Memorandum

FROM : EG44/Deputy Manager, Apollo G&N Project
OfficeIn reply refer to:
EG44-362-65

SUBJECT: Block II computer design deficiency

Figure 1

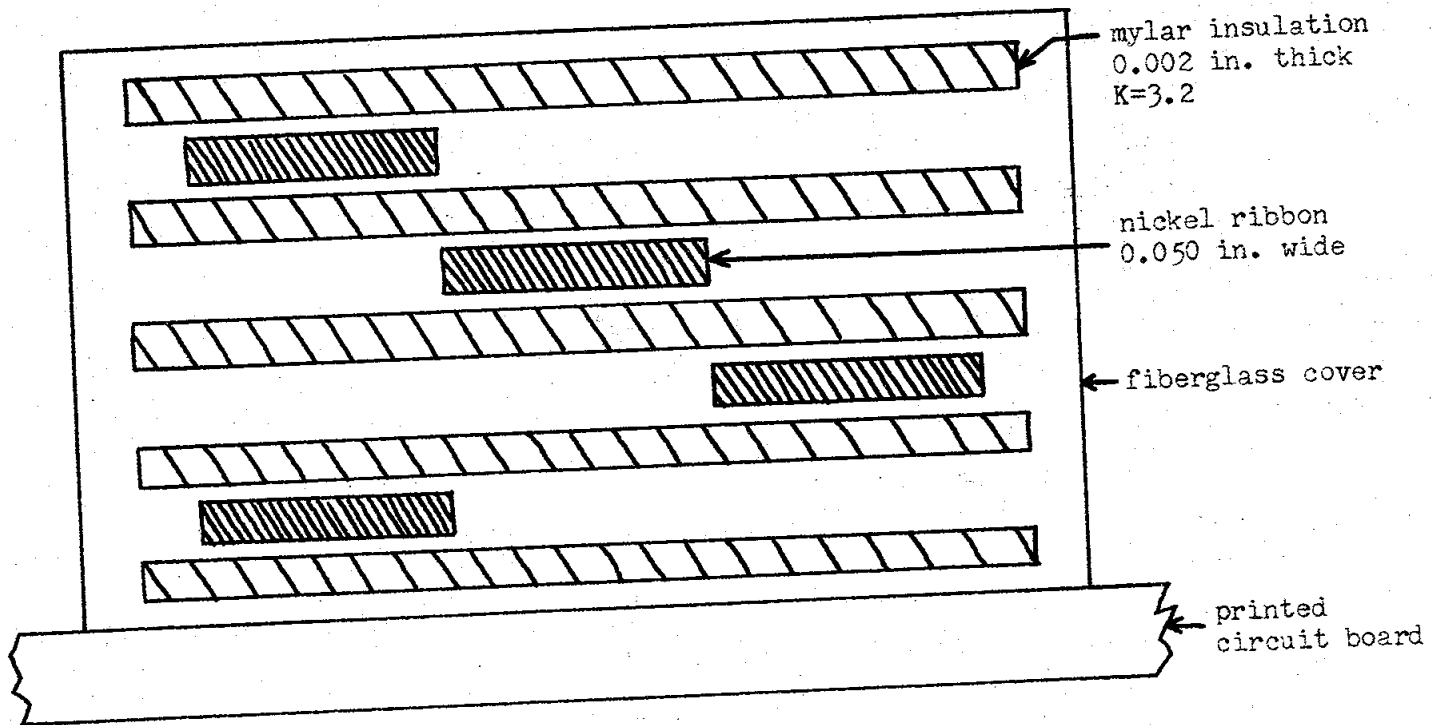
Problem - In the Block II computer MIT/IL based the design on a matrix capacitance of 100 picofarads. This is the measured value of the matrix of the Block I computer. However, the matrix fabrication was changed from a welded wire interconnect to a very dense nickel ribbon approach. Figure 1 is a cross section of the matrix. MIT/IL did not anticipate any increase in the matrix capacitance over the Block I design.

When the first tall logic sticks were delivered to MIT/IL the signal propagation time was so great, due to the high matrix capacitance, that the computer would not operate at design speed. The measured times, for the longest run length, are as follows:

As can be seen, the delay that is unique to tall logic configuration (T_u) is 50 nano seconds and the interconnect matrix delay is 300 nano seconds. The design value for the matrix delay was approximately 60 nano seconds.

Figure 2

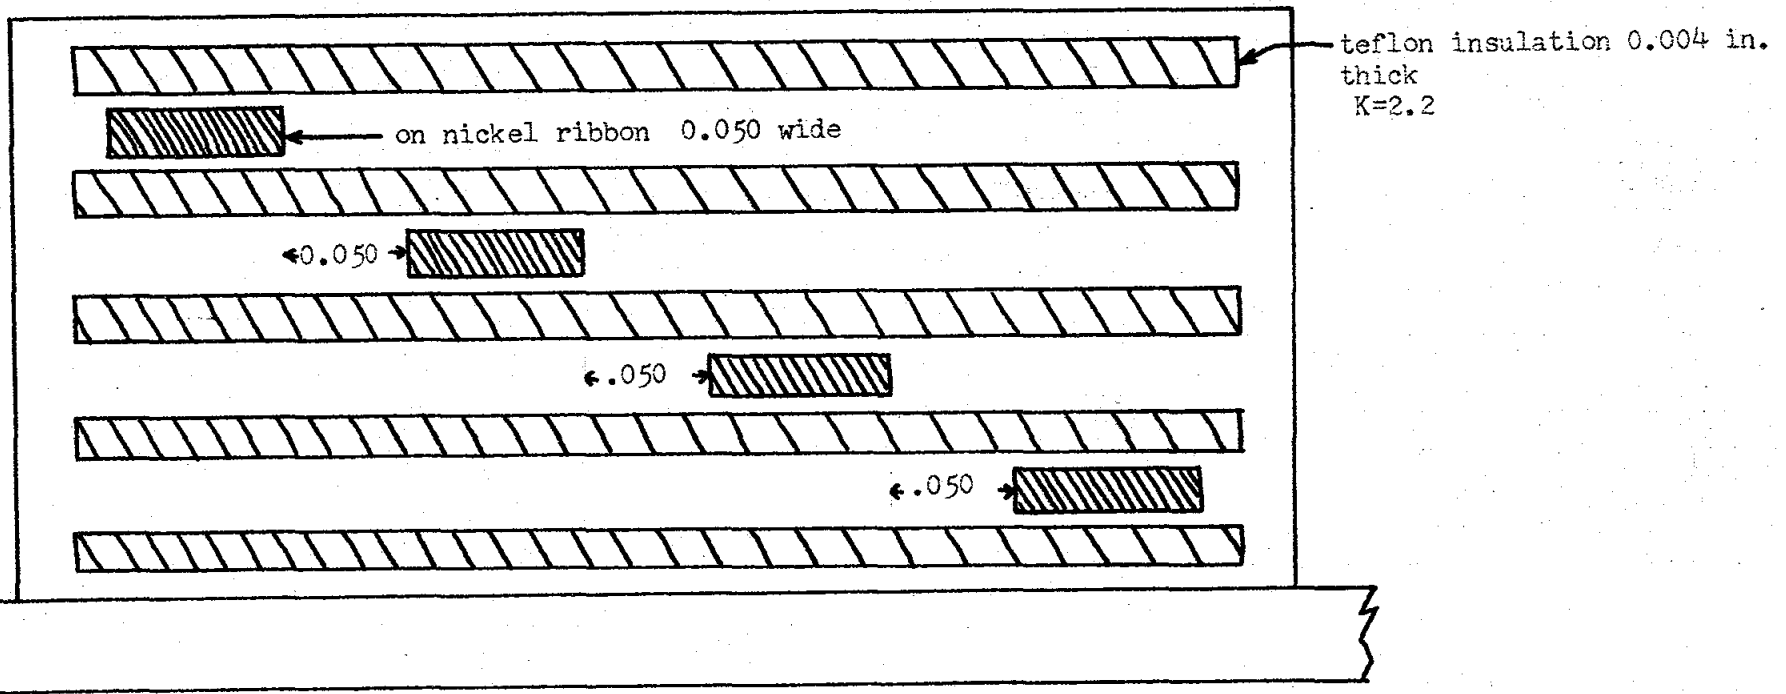
b. Modify the nickel ribbon matrix of computers 200 C, PC-1, PC-2 and possibly PC-3, to the four wide configuration, with teflon insulation, shown in figure 2. It is estimated that this will reduce the capacitance by a factor of 3.9 or more. Raytheon is fabricating an experimental matrix to demonstrate this approach. This will result in a combined unscrambler and interconnect matrix delay, in the tall stack configuration, which is slightly more than that obtained in a flight type computer with multilayer boards. This approach is necessary to provide easily modified breadboard computers which can be manufactured while the computer design is being verified. By using this method, the only computer delivery that will be delayed is 200 C which is a Raytheon system for PAC (core rope simulator) and FTM program checkout. Multilayer boards will also be procured for PC-1, PC-2, and 200 C in the event the changed ribbon matrix does not work. To provide a multilayer board backup, it is also recommended that tall logic and ribbon interconnect be provided, in parallel, for PC-3. This design cannot be used in flight type computers due to space limitations.
